BSjap17176-20260305- RMA ConResp-LLFA v3.docx

**PLANNING APPLICATION DM/25/2640
BROOKLEIGH PRIMARY SCHOOL, BURGESS HILL, WEST SUSSEX**

We refer to the Lead Local Flood Authority (LLFA) letter dated 28th January 2026, addressed to Mid Sussex Planning, in relation to the above-mentioned reserved matters planning application.

Figure 6.2 of the FRA is reproduced below for ease of reference:

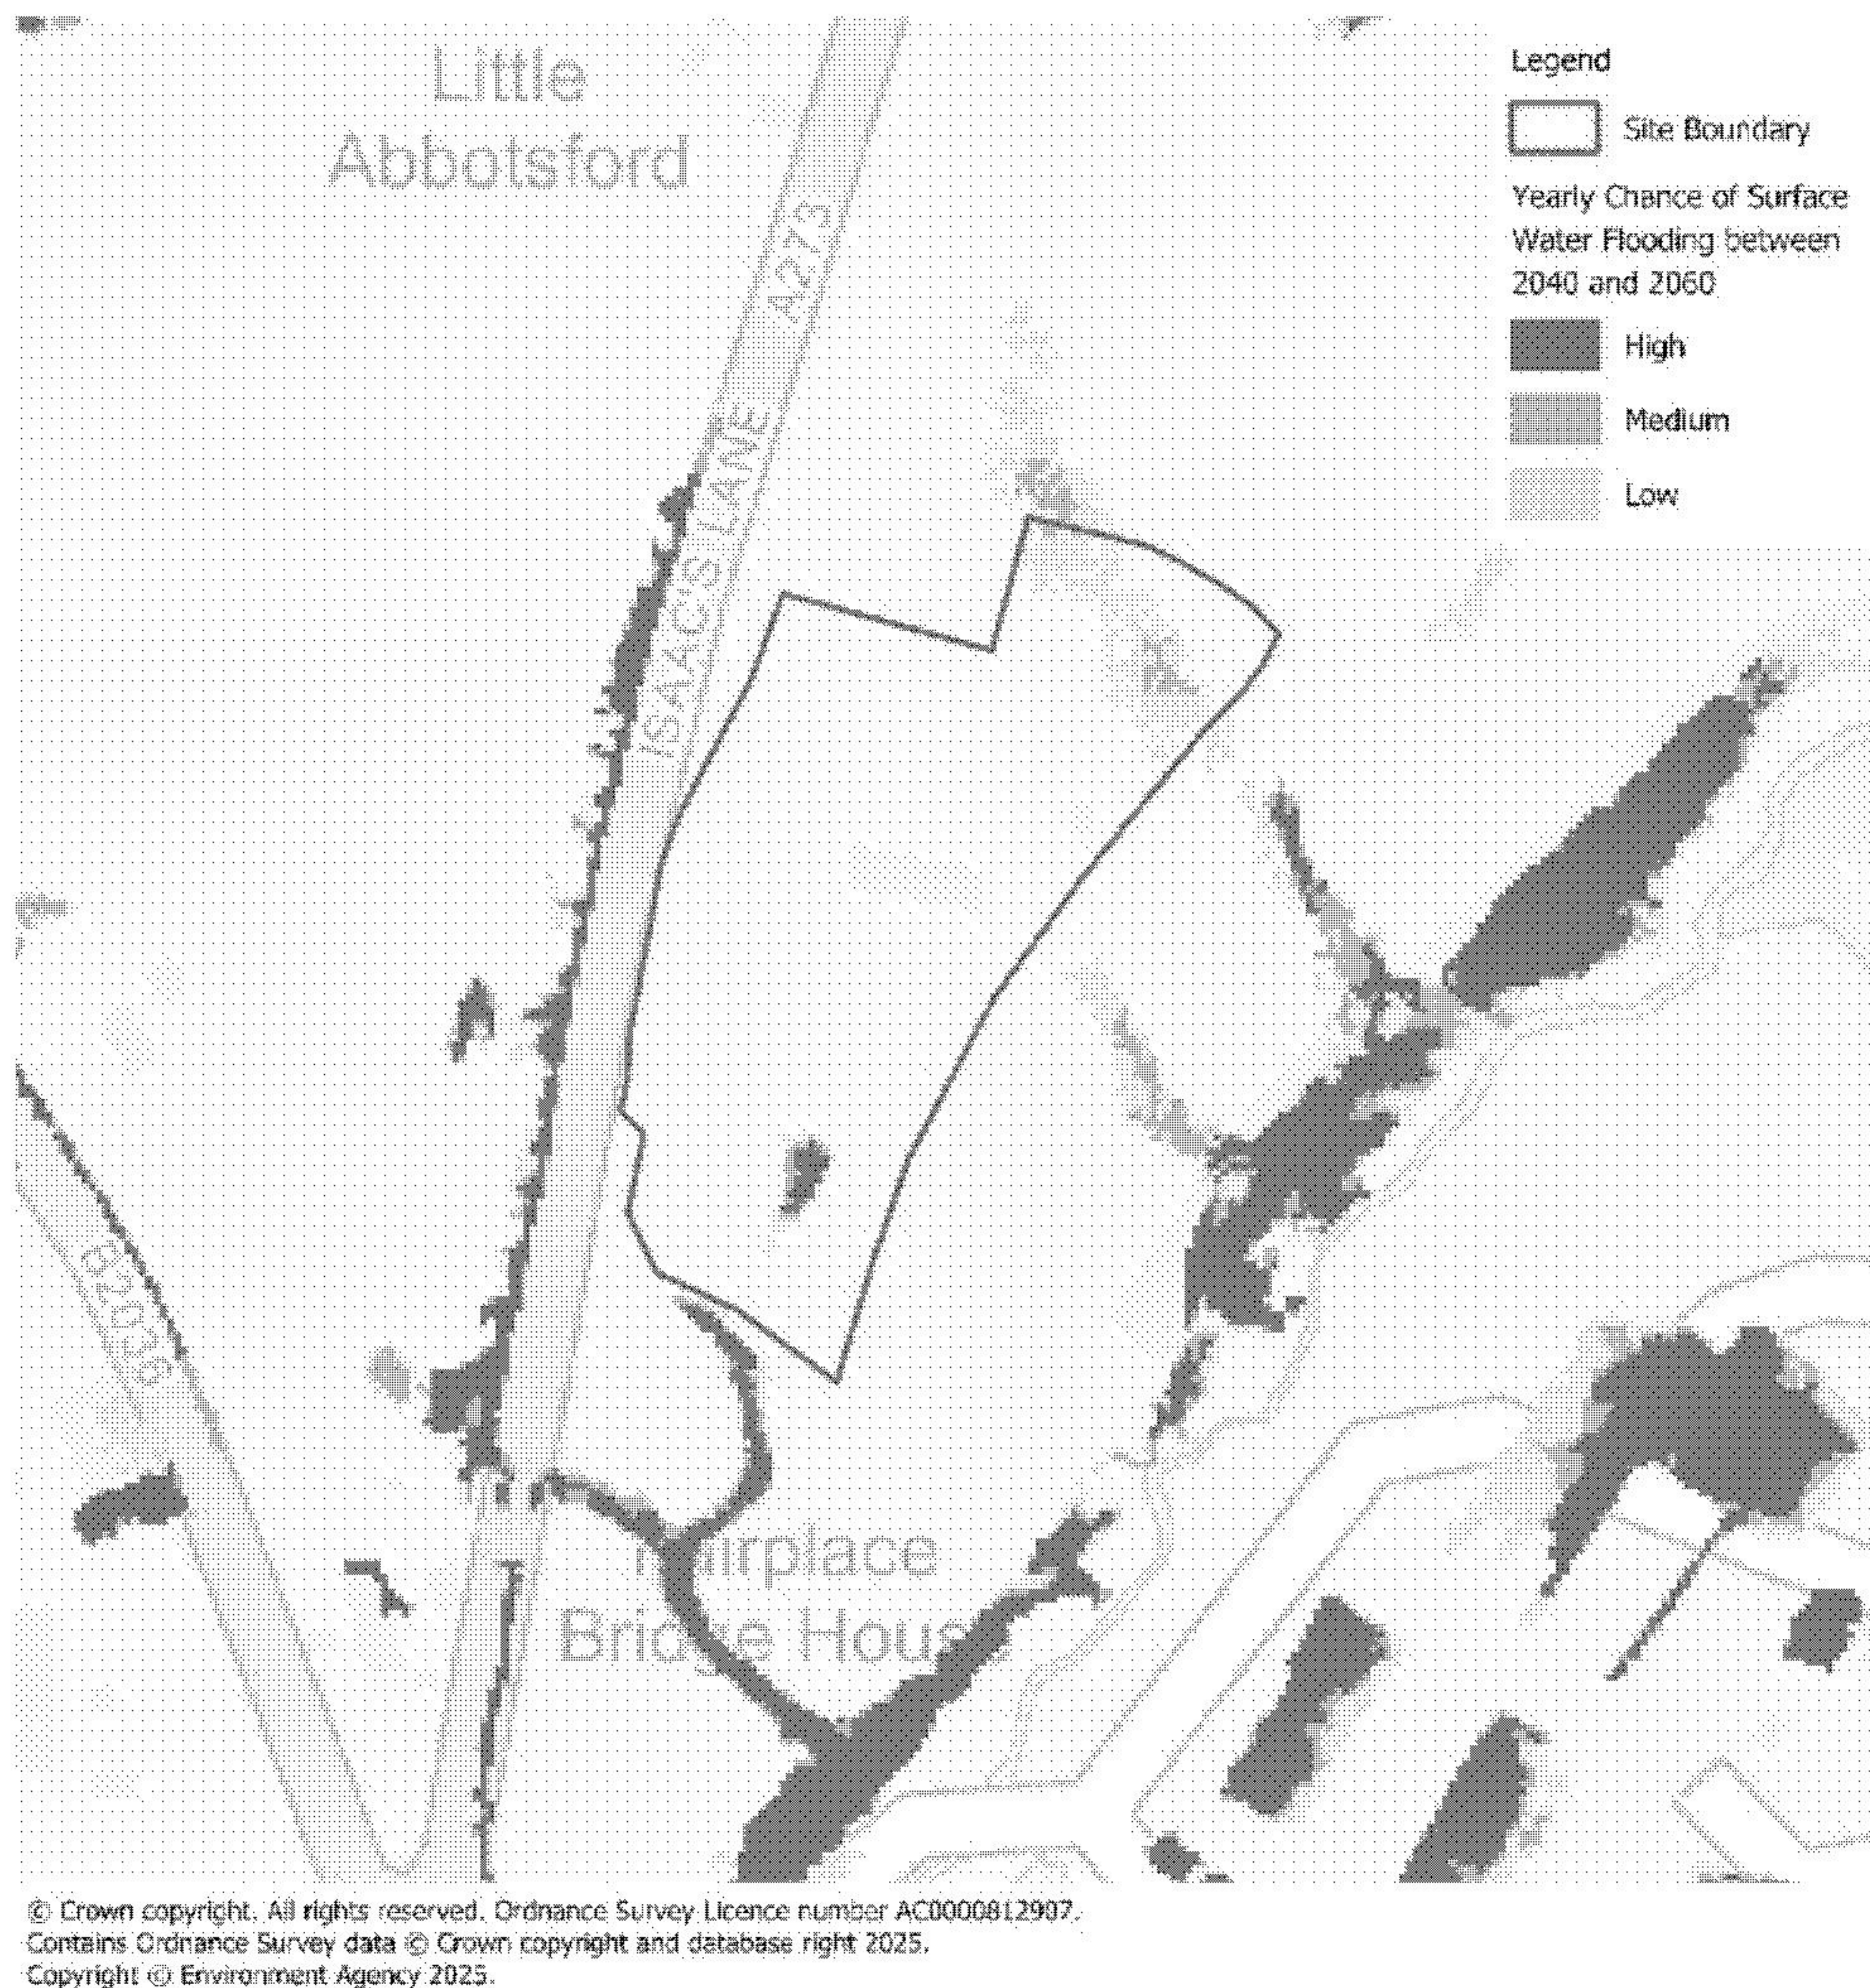
As noted on the extract of the RoFSW map, the majority of the surface water flooding across the Primary School site is classified as Low to Medium, with an isolated area shown as High, which corresponds to the area designated for the playing field for the school (no building located at that location). The proposed school building is indeed located within an area identified as having a Low to Medium risk of flooding from surface water.

The reserved matters application for the primary school should however not be considered in isolation and the drainage provisions noted under Permitted Development DM/19/3313 and now implemented in Holmbush Avenue, within its surface water and highway drainage network. The highway drainage network on Holmbush Avenue accounts for any runoff from the carriageway and the levels for the road are no longer as per the digital terrain modelled used to generate the RoFSW.

Risk of Surface Water Flooding

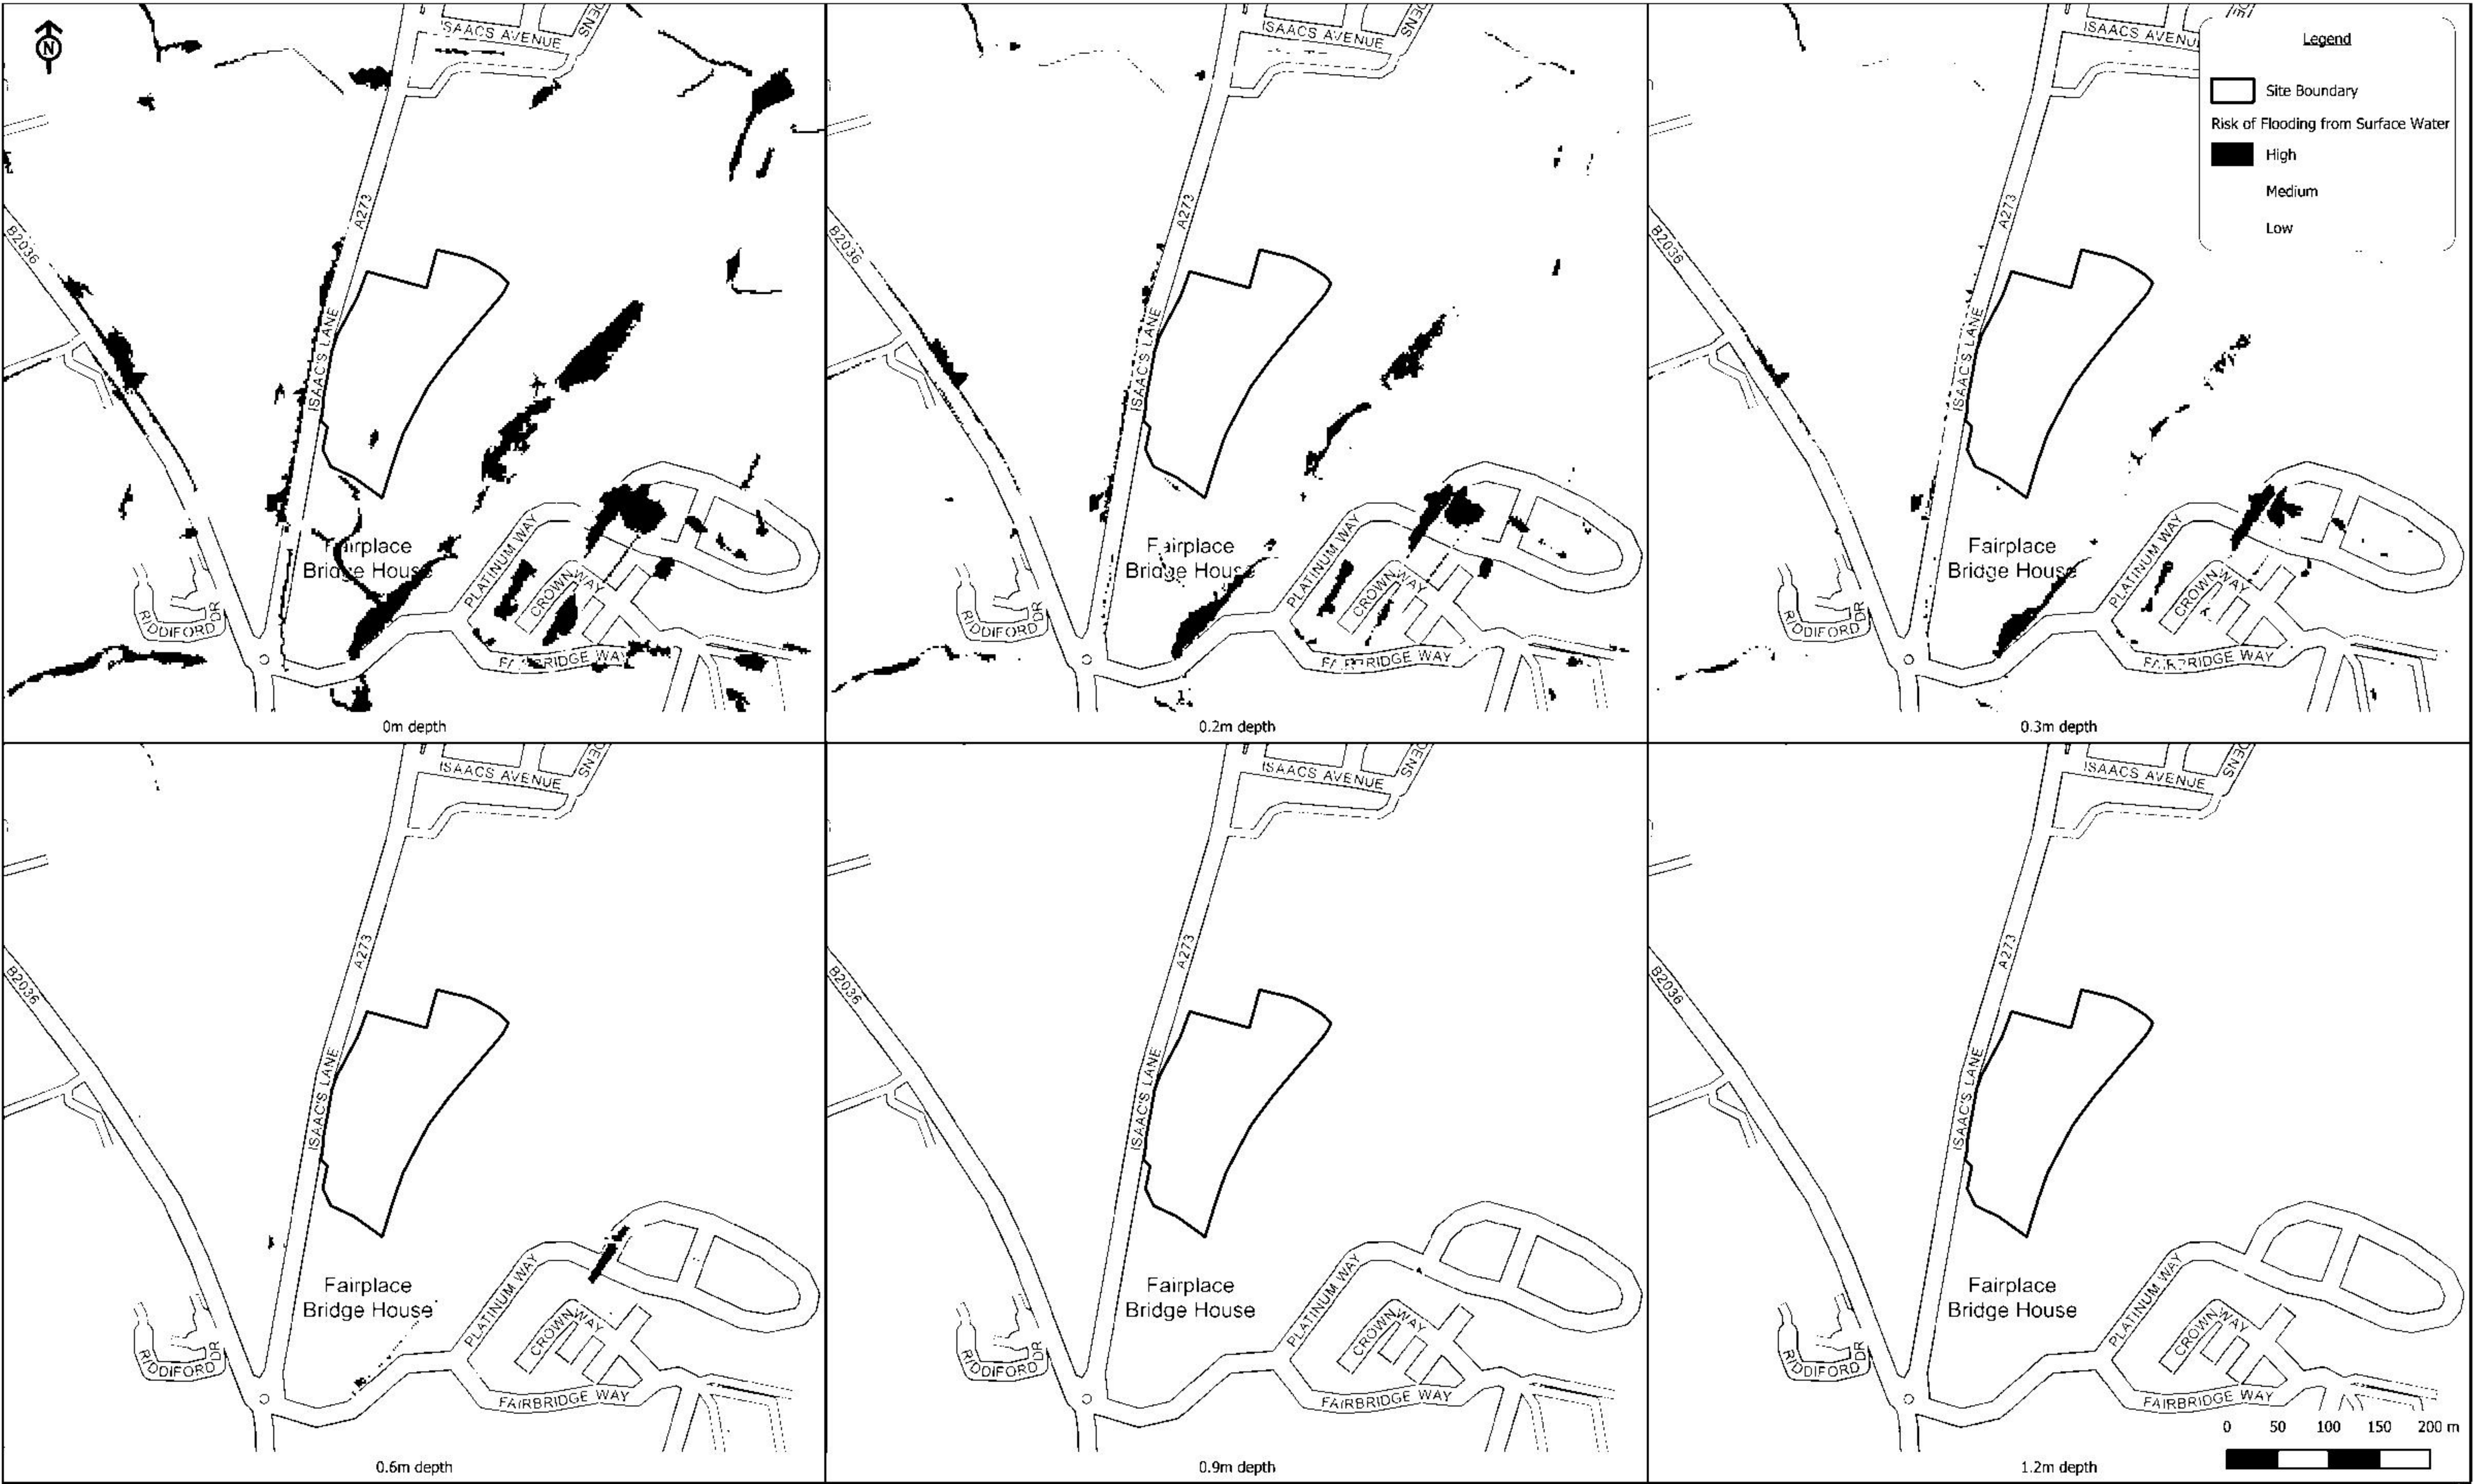
Focussing on the red application boundary for the primary school site only, we have extracted the NaFRA2 data published by Defra and reproduced the information onto the attached drawings 14176-CRH-XX-XX-FG-G-7023-P01 and 14176-CRH-XX-XX-FG-G-7024-P01 representing the current day RoFSW and the limited climate change scenarios for the period of 2040 to 2060. The Environment Agency plans to publish further climate change data in later updates to the NaFRA2 data, but these are not currently available.

Both drawings show the likelihood of surface water accumulations across the site within different anticipated flood depths. Of note the information does not show modelled flood depths, but rather the probability of occurrence of surface water flooding reaching that depth band. Analysis of that data indicates that the probability of occurrence of 0.0m depth of surface water accumulation where the proposed primary school building is to be located is classified as Low to Medium. The granularity of the area shown as Medium risk is very small in comparison. The probability of any surface water flooding occurring at any depth beyond the 0.0m is shown to be very low across all scenarios including consideration for climate change for the period up to 2060. This indicates that the probability of surface water flooding affecting the proposed development area is less than 0.1%, rarer than the 1 in 1000-year rainfall event. Of note, current guidance and all standards only require surface water flooding and drainage to be considered for up to the 1 in 100-year rainfall event (plus climate change), which is for a probability of occurrence greater than 1%.

Even when considering the area shown as High risk of flooding, the probability of occurrence for that event is only for a flood depth of 0.0m for up to the 2060 epoch, the probability of occurrence for any other event or flood depth is nil. From that review, the probability of the site being affected by surface water flood risk is very low to Low in all scenarios up to the 2060 epoch, based upon available information.
